Access Compliance Report

Public Rights-of-Way

(Curb Ramps)

Intersection ID: 50540	Main Street: DANIEL_DWAYNE_DR	Cross Street: LEMONGRASS_LN	Location: NE
ADA ID: 383FA49E212E	Ramp Type: PerpDiag	Initial Pass/Fail: Fail	Overall Compliance: No
Severity Score: 25			
Codes/Mitigation Info/Possible Solution		Field Measurements/Component Compliance

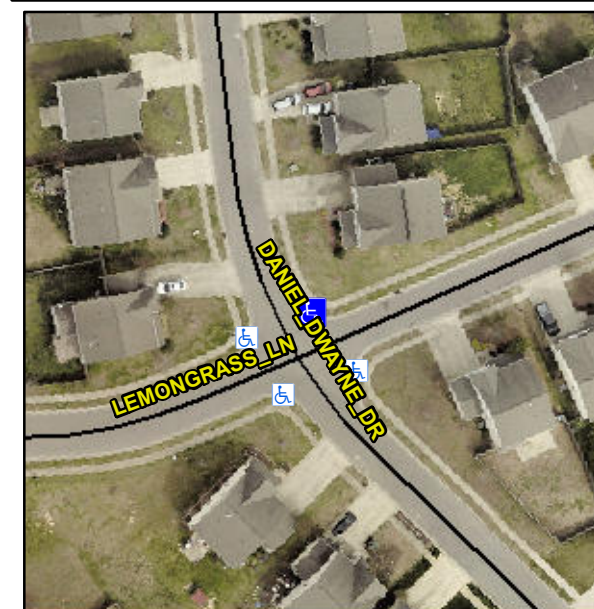
Surveyor Notes:

N/A

Not Found, R304.5.3

Remove & Replace Curb Ramp With Two New Directional Ramps or Equivalent.
